Value Added Product: **Acoustic Insulation**

Bulletin No: EB/25-26/002 Date: 29th March 2025

Introduction of Acoustic Insulation for Screw Chillers

Photo of screw compressor covered with acoustic insulation

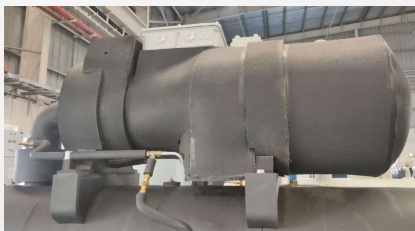
KCPL is pleased to introduce a new value-added product, **Acoustic Insulation**, now available as an optional feature for customers to buy. This product is specifically designed to address noise concerns in screw chiller installations where sound levels exceed 82 dBA at a 1-meter distance.

The **Acoustic Insulation** is composed of specialized noise-absorbing materials integrated within thermal insulation. It is wrapped around the compressor using a special adhesive to completely cover the compressor as shown in adjacent photo. To ensure proper application, the installation will be performed **exclusively by KCPL authorized personnel** as per standard approved procedure.

- Water-Cooled Screw Chillers: Approximately **2 dBA**
- Air-Cooled Screw Chillers: Approximately **3 dBA**
